PLANNING REPORT

PLANNING AND ZONING COMMISSION

Panera Drive-Thru 22-109AFDP

Case Summary

Proposed Improvements and Modifications

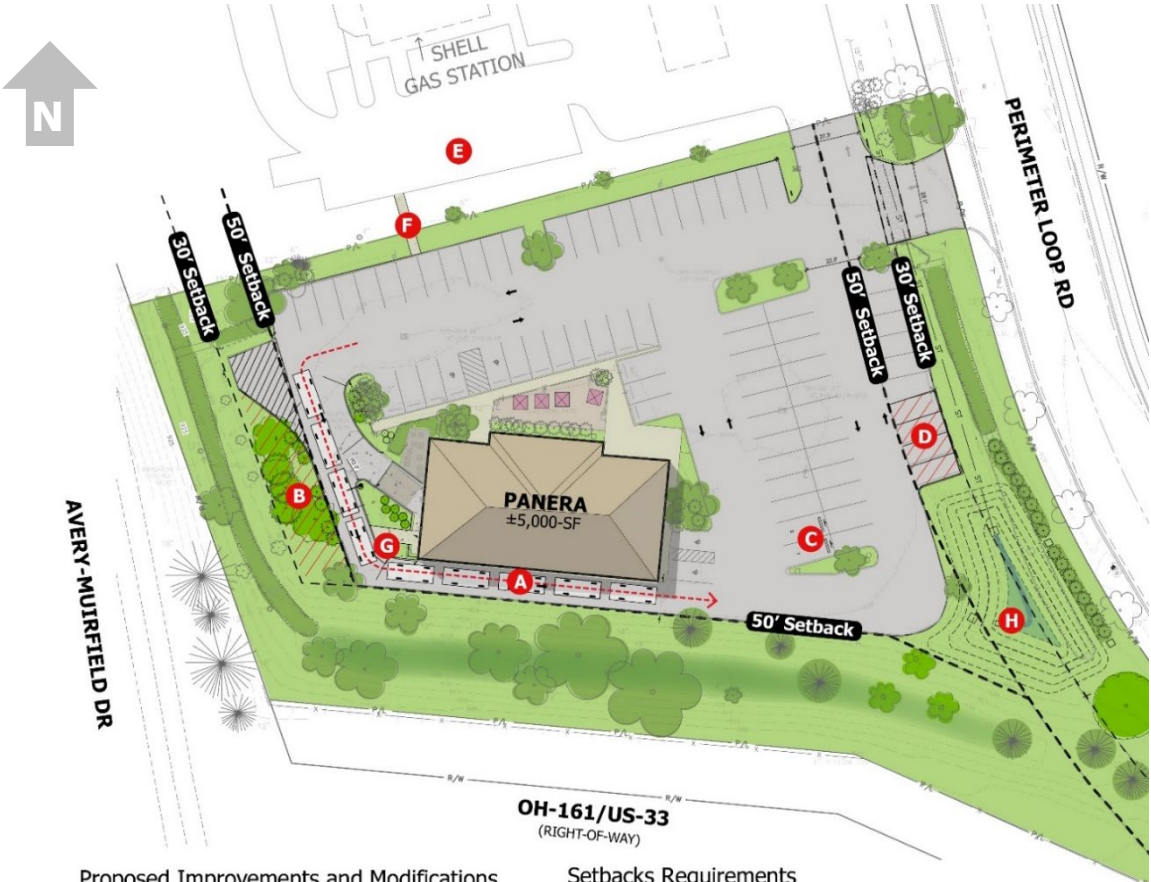
The applicant is proposing to repurpose an existing one-way lane at the rear of the building for a drive-thru lane. The existing drive lane at the rear of the building is less than 12-foot and does not meet the specification for a fire lane. The 50-foot building and pavement setback along OH-161/US-33 frontage would prohibit the widening of the existing lane to provide an “escape” lane.

The applicant is proposing a drive-thru height clearance bar painted Panera Slate to match other proposed site improvements. Staff recommends the "DRIVE-THRU" text and the white circle with the number 1 be omitted from the clearance bar to maintain the character of the development. The applicant is also proposing to move the cloth awnings at the rear of the building for drive-thru clearance. However, the existing awnings do not extent beyond the curb into the drive-thru lane and there are existing exterior building vents/elements directly above the existing top awning line. Additionally, the awnings are a design element adding to the character of the building and are integrated into building design throughout Perimeter Center which adds to the cohesive aesthetic of the larger development. Staff recommends the applicant work with Staff to resolve the awning placement while retaining the aesthetic value the awnings add to the building and larger development's character.

The applicant is proposing to remove 11 spaces along the west edge of the site (Avery-Muirfield Dr.) and to construct 4 new spaces along the east of the existing parking area to replace a portion of the removed parking. Additionally, the applicant is proposing to reserve two existing parking space for drive-thru pull-ahead parking, these two spaces do not contribute to the total parking provided. Site modifications would result in a net loss of 9 parking spaces on-site (5 less than the previously approved parking reduction). The applicant has entered into a shared parking agreement with the adjacent Shell gas station to provide 8 parking spaces for shared parking. The applicant is proposing a sidewalk 4-foot in width to connect to the shared parking. A total of 80 parking spaces would be provided for patrons (2 less than the previously approved parking reduction).

The applicant is proposing to remove pavement closest to Avery-Muirfield Drive. Where pavement is removed the applicant is proposing to landscape with additional trees and shrubs to add to the existing landscape in the setback. Additionally, proposed pavement modification to accommodate the drive-thru provide an additional pocket of landscape to further screen the existing enclosed refuge area west of the building.

To enable the 4 new parking spaces the applicant is proposing to modify the existing 3,500 SF dry-basin, storm line, and replace pavement and curb for a section of the entry drive from Perimeter Loop. The proposed modifications meet the City's stormwater management Code requirements. The pavement removal elsewhere on the site would result in a slight reduction in total impervious surface (lot coverage) from 49.9% to 48.9%. Other site improvements do not impact public services to the site.

Previous applications have submitted for preview menu board and have been denied by the Commission. Because the development text place a high importance of limiting the graphic clutter within the development, Staff recommends that the applicant remove the proposed preview digital menu board from the proposal to follow precedent set forth with previous applications.

- 1) The applicant resolve the awning placement while retaining the aesthetic value the awnings add to the building's character, subject to Staff approval;
- 2) The "DRIVE-THRU" text and the white circle with the number one be omitted from the drive-thru clearance bar prior to submitting for a building permit; and
- 3) The applicant remove the digital preview menu board from the proposal to be consistent with previous approvals when submitting for a building permit.
